**Subject:** Submission of Inspection Report of NEC funded project titled “**Construction of Mini Outdoor Stadium at Senapati Public Ground, Senapati District, Manipur**”.

**Report of the inspection carried on 23/03/2021 for the NEC funded project "Construction of Mini Outdoor Stadium at Senapati Public Ground, Senapati District, Manipur."**

View of Gallery &  
Below is a photo showing column size

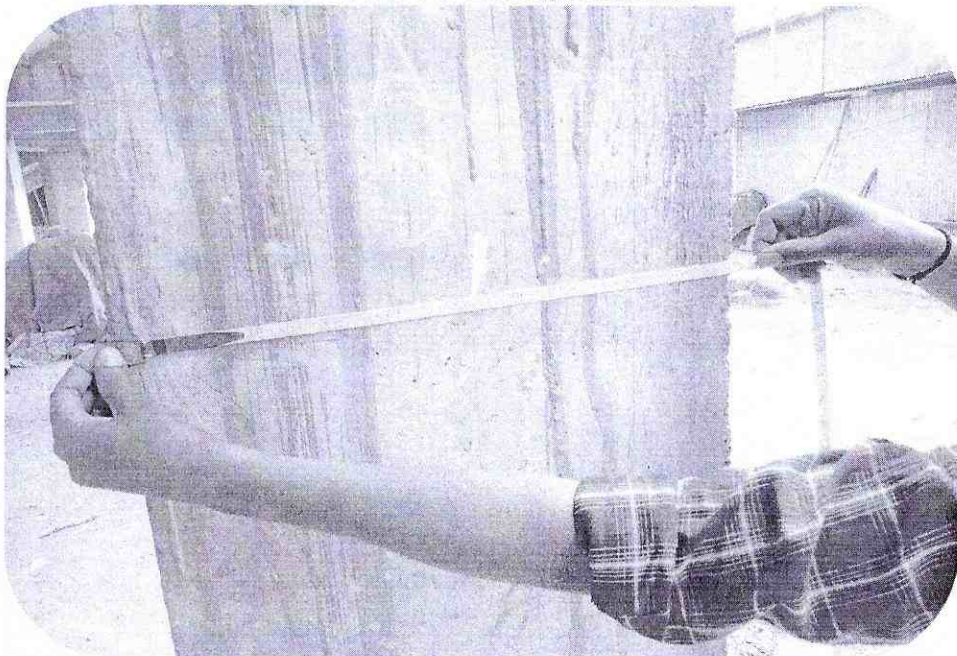
- The width of top cantilever slab and front pedestrian movement slab is less than approved DPR i.e. 1m and 1.5m.
- The area and height of the Gallery was constructed as per specification mentioned in approved DPR. The sizes of all the columns constructed at site were (0.50x0.48)m whereas in DPR 92nos of column is of (0.45x0.45)m and 4nos is of (0.6x0.6)m.
